From: Henry Lister <halister@bellsouth.net>
Sent: Wednesday, October 11, 2023 2:58 PM
To: All Agenda Materials <allclerk@townofchapelhill.org>; Town Council <mayorandcouncil@townofchapelhill.org>
Subject: Hillmont materials for Town Council meeting 10/11

Traffic Concerns Regarding the Hillmont Proposal
Submitted by Henry Lister, supported by residents of Sherwood Forest
October 11, 2023

SUBJECT: Woodmont on NC 54 East Application for Master Land Use Plan
(File No. 9798-04-71-8729)

Proposed Pedestrian Walkway for Stancell Roads

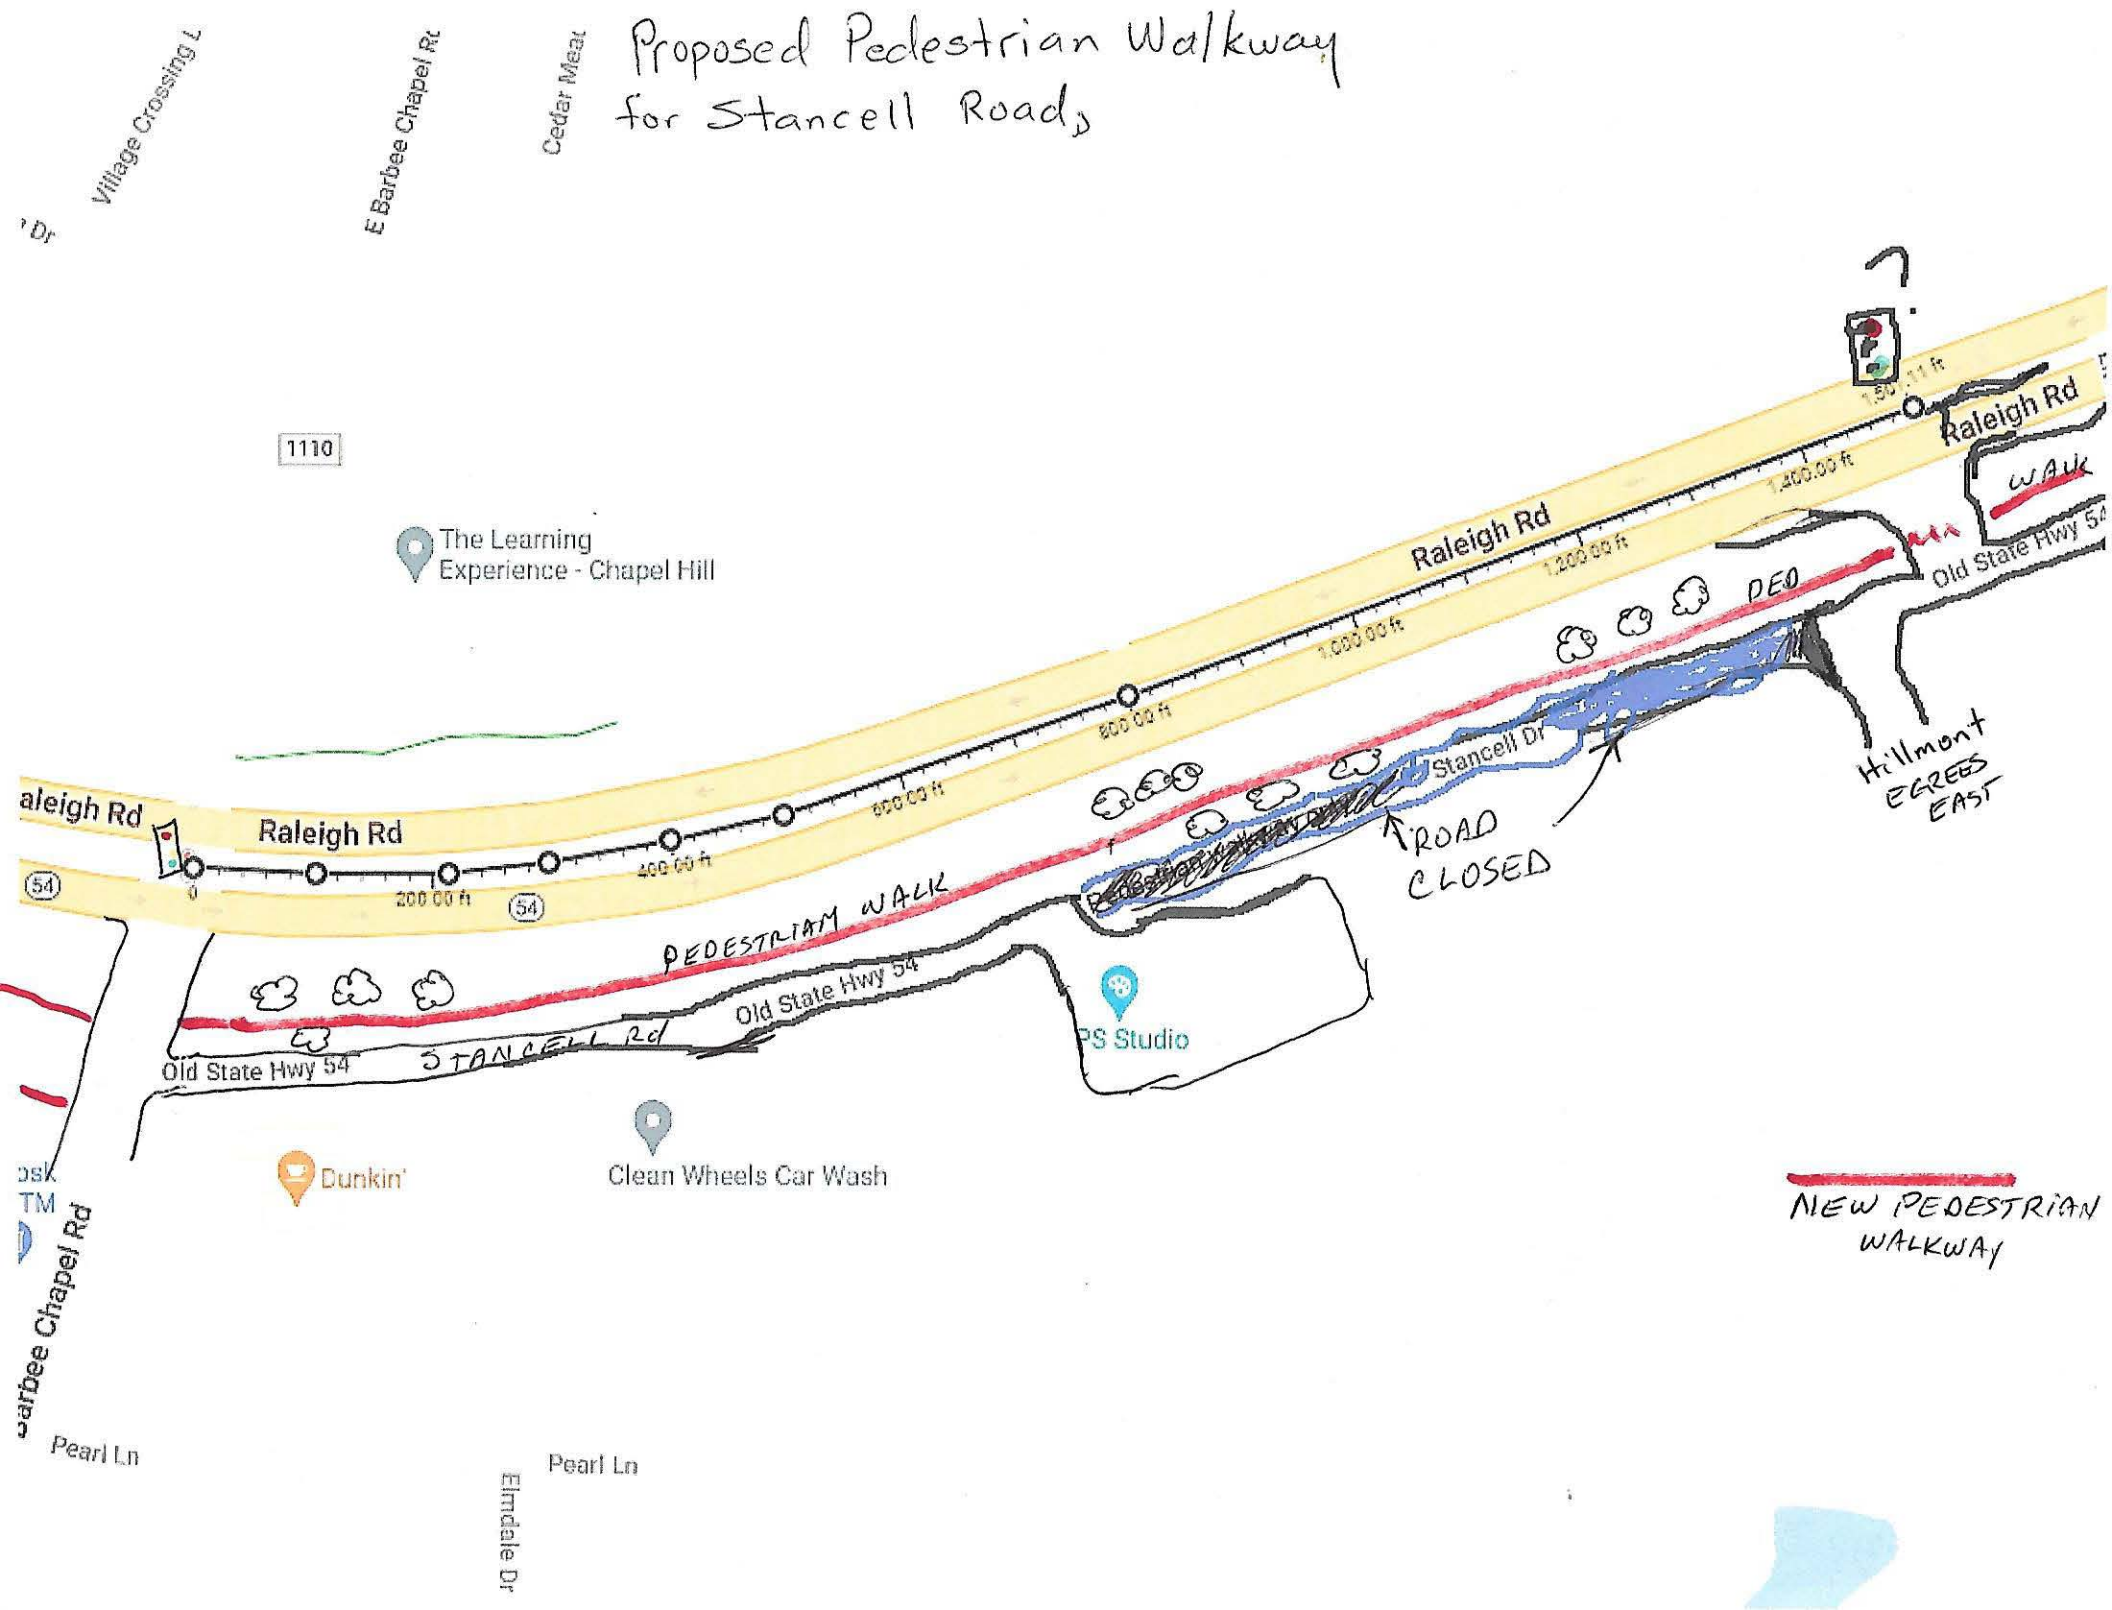
1. Close Stancell Road between the PhotoShop and the east egress proposed by Hillmont. Close Little John Road's access to NC-54, and create a new traffic lighted outlet onto NC-54 to accommodate Sherwood Forest and Hillmont traffic.
2. Create a pedestrian pathway through the verge between NC-54 and Stancell Road extending from Barbee Chapel Road to Downing Creek. This path would be 6-foot wide and landscaped like much of the path adjacent to the 54 East office buildings.

The goal of these recommendations is to mitigate the extensive traffic created by the Hillmont development while creating new pedestrian opportunities. We hope that you appreciate the difficulty any new traffic poses to an already vexing problem in this area that would be exacerbated by Hillmont.

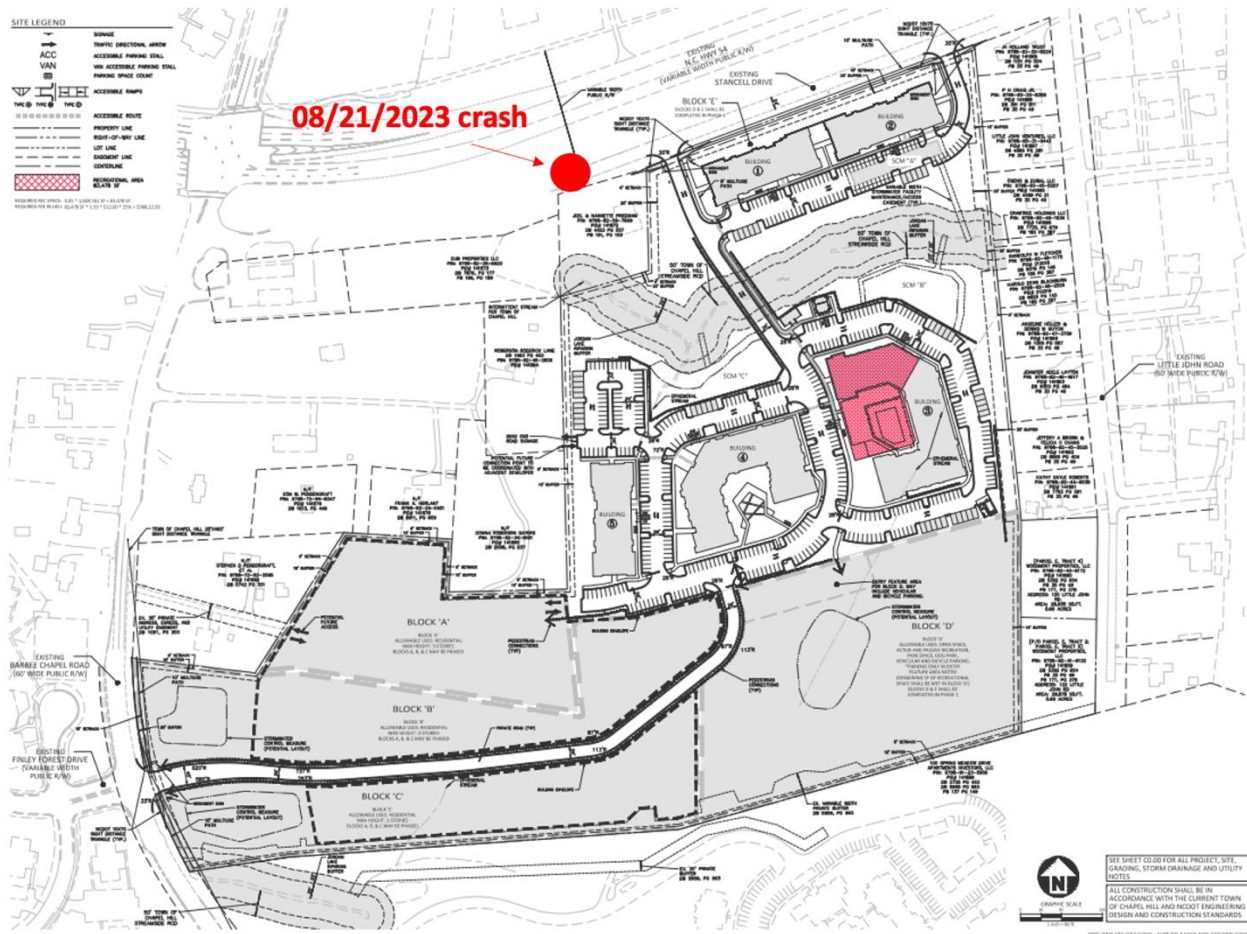
2. Pedestrian and bicycle paths. Most of NC 54 has an asphalt path, well maintained and amidst trees and bushes along the south border from Barbee Chapel Road to where the 54-501 bypass bridge crosses Raleigh Road. However, from Barbee Chapel Rd to Downing Creek pedestrians use

Stancell Road. (See accounts provided to you by residents about the problems between cars and pedestrians on Stancell Rd.)

A suitable solution is to extend a path in the verge between NC54 and Stancell Road. This pathway could be landscaped and provide a much needed and safer pedestrian walkway to Downing Creek and Sherwood Forest. (See handout drawing, "Proposed Pedestrian Walkway for Stancell Road").
